<b>CITY OF WESTMINSTER</b>			
<b>PLANNING APPLICATIONS COMMITTEE</b>	<b>Date</b> 13 September 2016	<b>Classification</b> For General Release	
<b>Report of</b> Director of Planning		<b>Ward(s) involved</b> Hyde Park	
<b>Subject of Report</b>	33 Westbourne Terrace, London, W2 3UR,		
<b>Proposal</b>	Internal works to the building including the installation of a new lift associated with the reconfiguration of the existing residential accommodation to provide six residential dwellings. External works to include the replacement of windows, new windows, secondary glazing, works at roof level, provision of cycle and car parking spaces and associated refuse areas.		
<b>Agent</b>	DP9		
<b>On behalf of</b>	West Two Properties		
<b>Registered Number</b>	16/03029/FULL and 16/03030/LBC	<b>Date amended/ completed</b>	12 May 2016
<b>Date Application Received</b>	5 April 2016		
<b>Historic Building Grade</b>	Grade II listed

<b>Conservation Area</b>	Bayswater

**Proposed Fourth Floor**

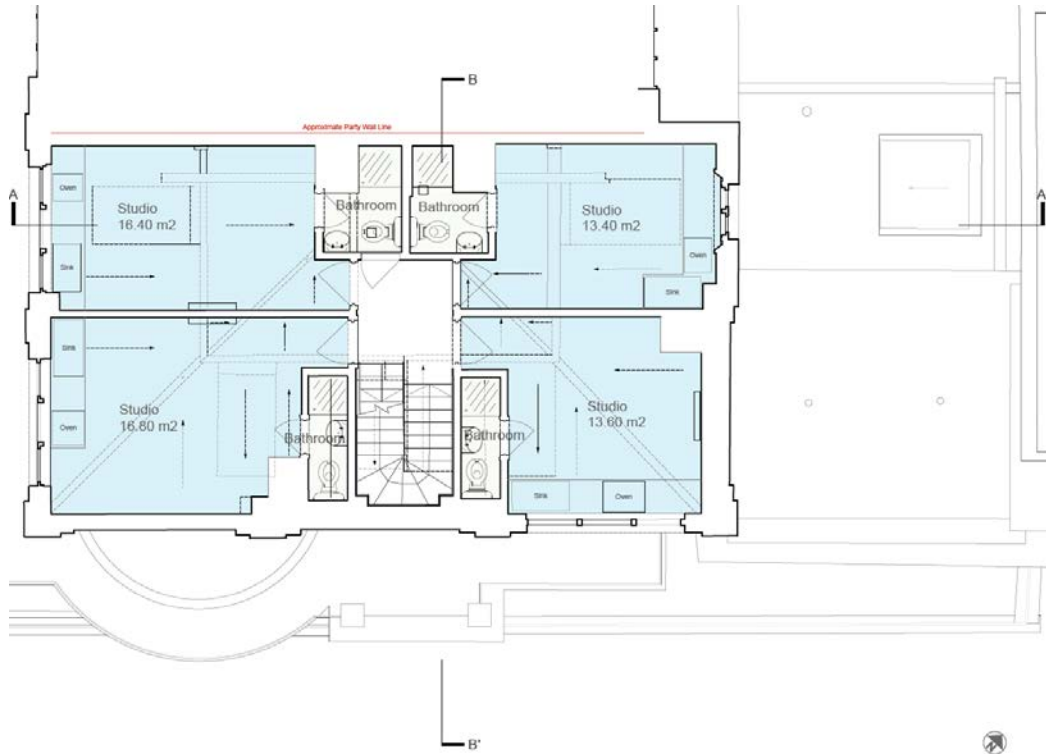
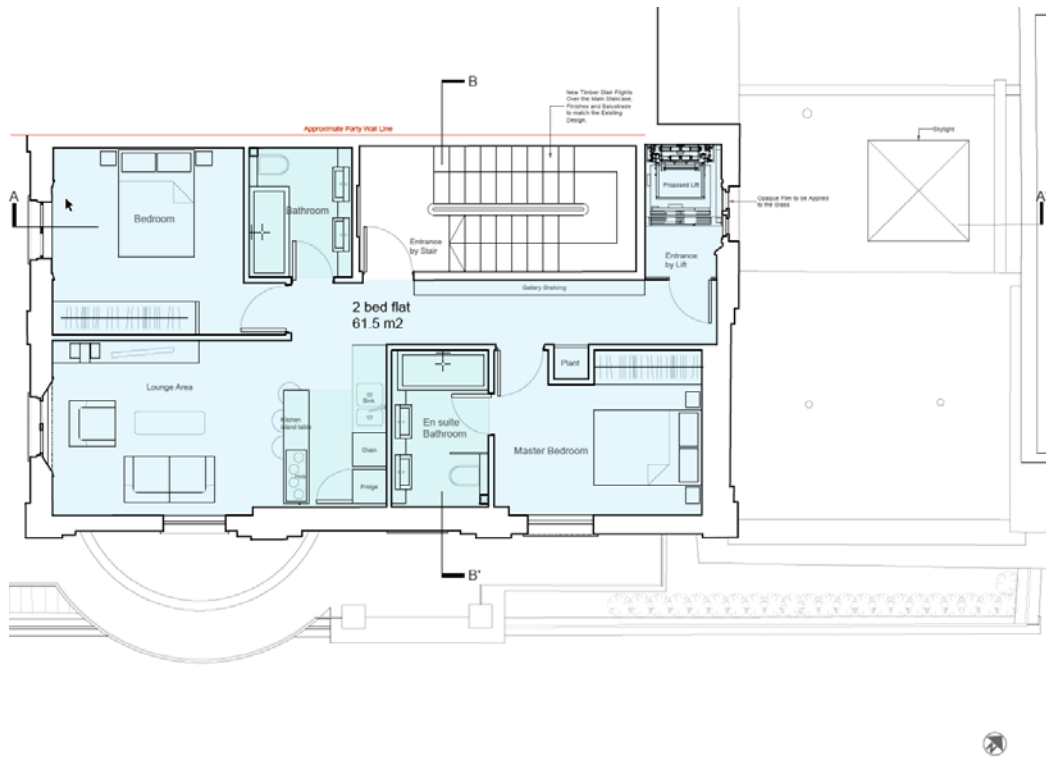
The building currently has five dormers to roof level, three to the Craven Road elevation, one to the rear elevation and one to the Westbourne Terrace elevation. These are later additions to the building, though of uncertain age. The three dormers to the Craven Road elevation remain unchanged as part of this application. The dormer on the rear elevation is to be extended up to the inside edge of the parapet and the dormer facing Westbourne Terrace is proposed to be extended onto the front parapet and both widened and repositioned to the north.

However, the front dormer would be unacceptable. The building occupies a prominent corner site on Westbourne Terrace which is one of the principal routes through Bayswater. The terraces to Westbourne Terrace were originally designed with, and still retain, a clear impression of being seen as palace fronted compositions with the end bays and central bays having sheer elevations to their top floor level, with visually subservient mansard top floors between these principal central and end bays. To a street junction such as this, each of the four terraces terminating at the junction has its end bays rising to a sheer top and giving a distinct grandeur to the townscape, with their roof structures deliberately kept very low in profile so as not to break the strong, sheer classical composition of the buildings and terrace as a whole to ensure they read clearly as the end blocks to each palace fronted composition. There is some limited variety now to the designs of these top floors on the junction, but the original design conception is still clearly apparent.

The existing front dormer is visible from the west side of the street and from further west down Craven Road though it is relatively low profile to the roof. The extension of the dormer forward onto the front parapet and its increase in width would significantly increase its visual impact on the building. This would harm the character and appearance of this building, the architectural conception of this terrace as having end bays and the classical character of the building. When seen above this composition, the enlarged and more prominent dormer would have a wholly inappropriate and cluttering impression, harmful to the character and appearance of the building, terrace and conservation area as a whole.

The front dormer is also relocated adjacent to the north party wall, which also serves as an inappropriate alteration. In this position it would be markedly set off line with the windows below, further serving to highlight its inappropriateness and lack of integration with the special architectural and historic interest of this listed building and the character and appearance of the area.

- 5 Because of its size, design and location, the enlarged dormer window to the Westbourne Terrace elevation would harm the character and appearance of this grade II listed building. It would also fail to maintain or improve (preserve or enhance) the character and appearance of the Bayswater Conservation Area. This would not meet S25 and S28 of Westminster's City Plan (July 2016) and DES 1, DES 6, DES 9, DES 10 (A) and paras 10.108 to 10.146 of our Unitary Development Plan that we adopted in January 2007. (X17AC)
